RENOVATE FIRST FLOOR OF
DIETRICK HALL AND PLAZA

MARK	DATE	DESCRIPTION
1	22 NOV 2021	ADDENDUM 02
13	OCT 2021	ISSUE FOR BID
27	SEP 2021	UBO REVIEW

PARTIAL FIRST FLOOR
PLAN - AREA B -
DEMOLITION

MD104

**PARTIAL FIRST FLOOR
PLAN - AREA B -
DUCTWORK**

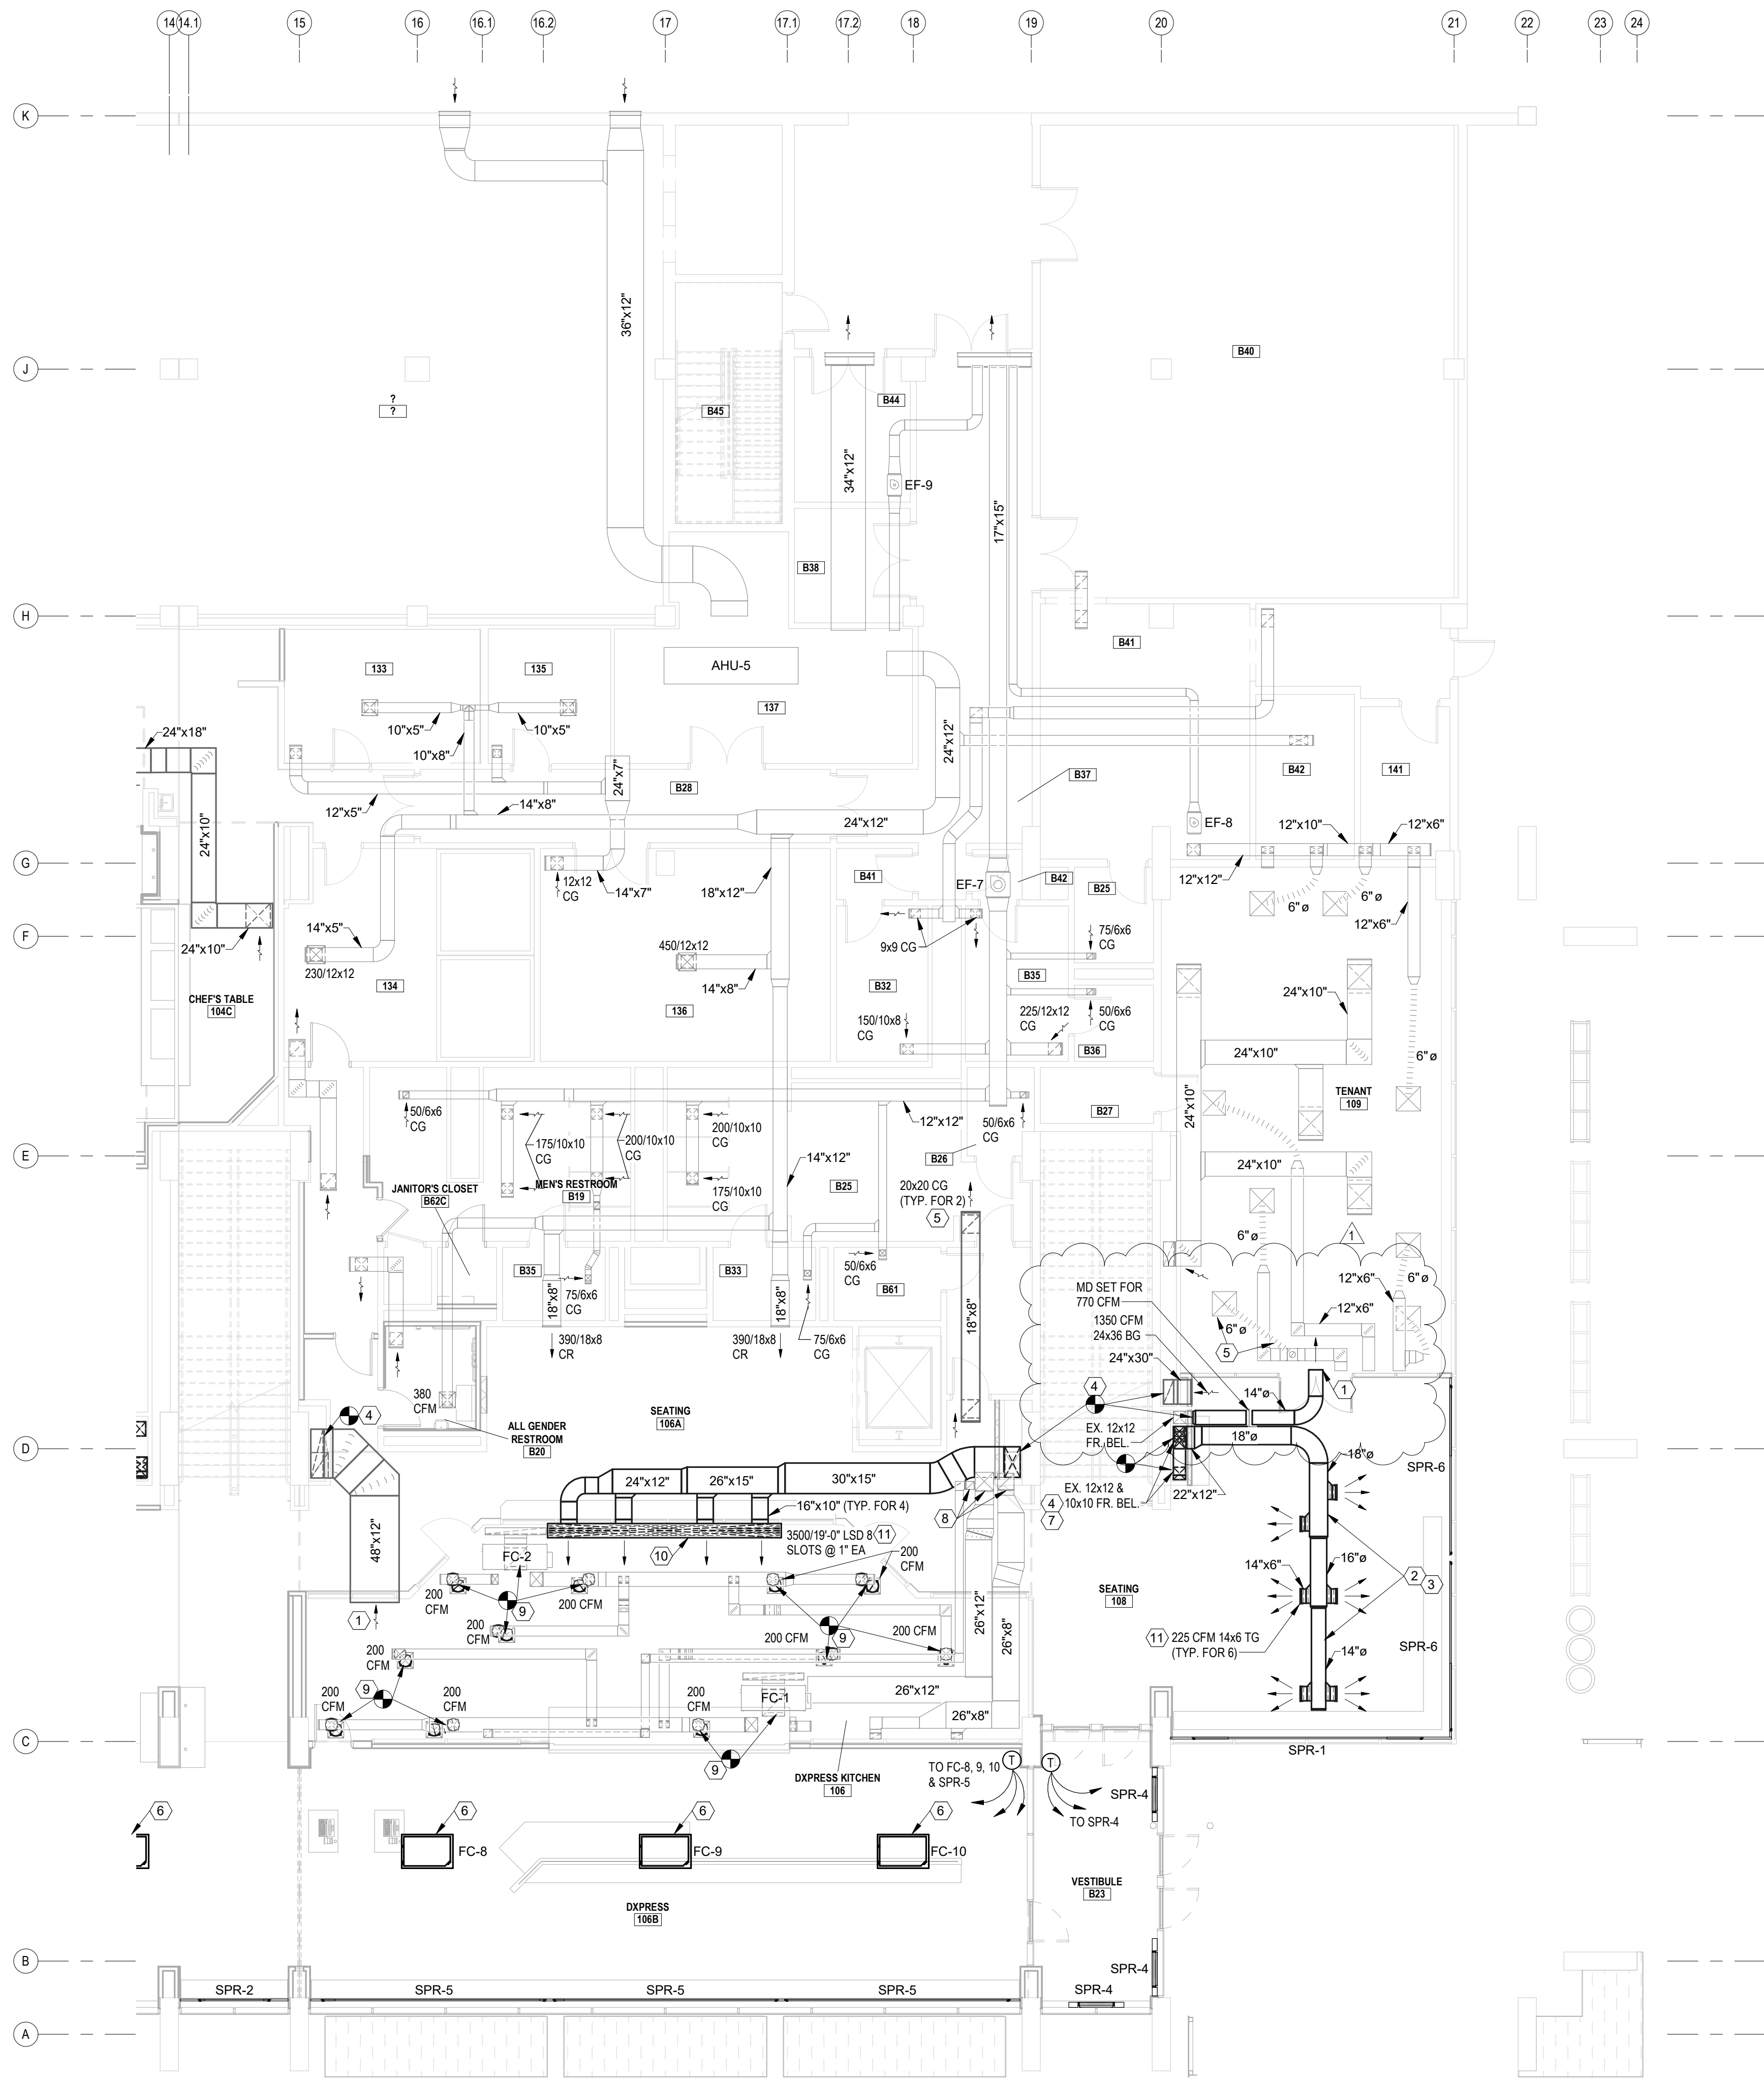
MARK	DATE	DESCRIPTION
1	22 NOV 2021	ADDENDUM 02
13	OCT 2021	ISSUE FOR BID
27	SEP 2021	UBO REVIEW
